**re: Geotechnical Design Summary Details**  
**Proposed Residential Development**  
**5331 Fernbank Road – Ottawa, Ontario**

**file:** PG5683-MEMO.02 Revision 4

Further to your request and authorization, Paterson Group (Paterson) prepared the current memorandum to provide a grading, servicing and landscape review for the proposed residential development. The following memorandum should be read in conjunction with the Geotechnical Investigation Report (Paterson Report PG5683-1 Revision 1, dated November 13, 2025).

CITY OF OTTAWA 5331 FERNBANK ROAD IRON VALLEY 2		PROJECT No. 121011-00	
DRAWING NAME GENERAL PLAN OF SERVICES		REV # 6	
		DRAWING No. 121011-GP2

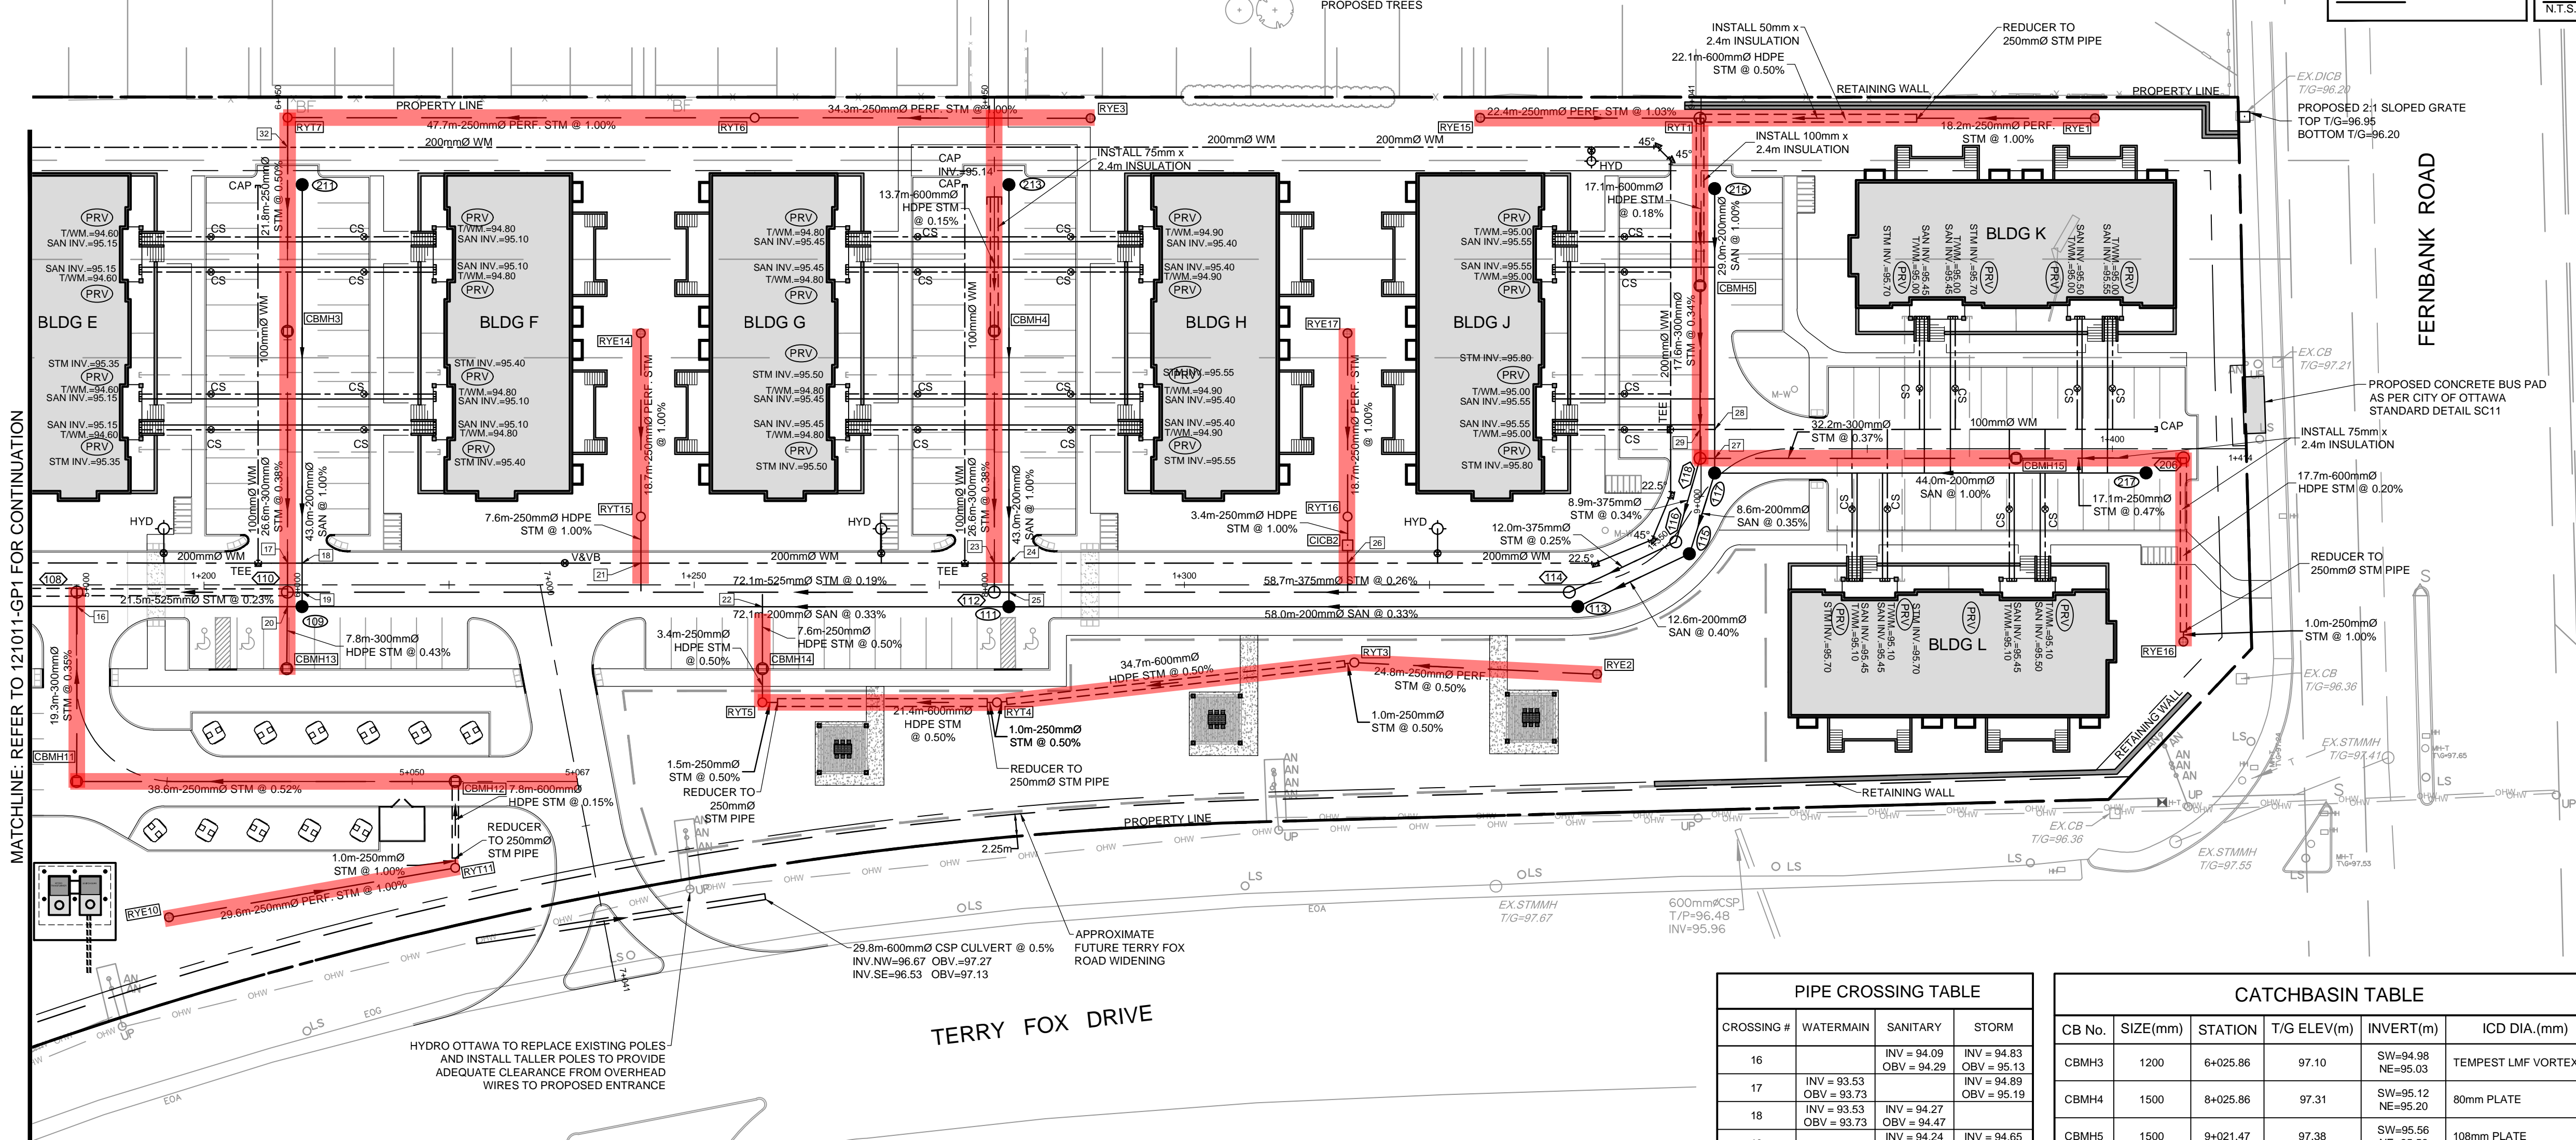
From our review of the above-noted site servicing plan, a number of servicing pipe sections are not provided with sufficient soil cover of 2.1 m for adequate frost protection (measured from the proposed ground surface to the pipe obvert). Reference should be made to the marked-up servicing plans which show the areas with insufficient soil cover, attached to the current report.

- Pipes with insufficient soil cover

For services with less than 2.1 m soil cover, a combination of soil cover and rigid insulation should be used, as detailed in Table 1 below.

Table 1 – Rigid Insulation Recommendations for Pipes with Reduced Soil Cover			
Thermal Condition	Soil Cover Provided (mm)	Insulation Dimensions	
		Thickness (mm)	Extension (mm)
Unheated	1800-2000	25	Extend 600 mm horizontally beyond edge of the pipe
	1500-1800	50	Extend 900 mm horizontally beyond edge of the pipe
	1200-1500	75	Extend 1200 mm horizontally beyond edge of the pipe

Alternatively, instead of extending the rigid insulation 600 to 1200 mm beyond the edge of the pipe, the rigid insulation can be “boxed” around the pipe by transitioning from horizontal to vertical placement of the rigid insulation and extending to the invert pipe elevation, effectively forming a box of rigid insulation around the pipe. In this case, the rigid insulation should still be extended far enough to provide adequate spring-line and cover backfill material around the pipe.

**L.1**

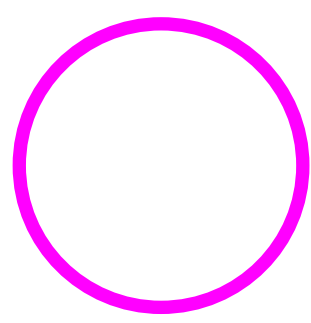
Based on the above-noted drawing, a minimum setback of 4.5 m from the nearest building foundation is provided for the majority of the proposed trees at the subject site. However, a small number of trees are not provided with the required 4.5 m setback. Reference should be made to the marked-up landscaping plans which show the trees with an insufficient setback, attached to the current memorandum.

- Indicates the minimum 4.5 m setback from building foundation is not provided.

Per discussion with JBLA, the proposed trees will consist of Japanese Lilac trees with a shallow, non-aggressive root system. Furthermore, it is understood that the remainder of the conditions noted in Subsection 3.1 of the current report will be incorporated into the design of the proposed development.

Accordingly, the proposed landscaping design is acceptable from a geotechnical perspective and is in conformance with Paterson's recommendations provided in the aforementioned geotechnical investigation report.
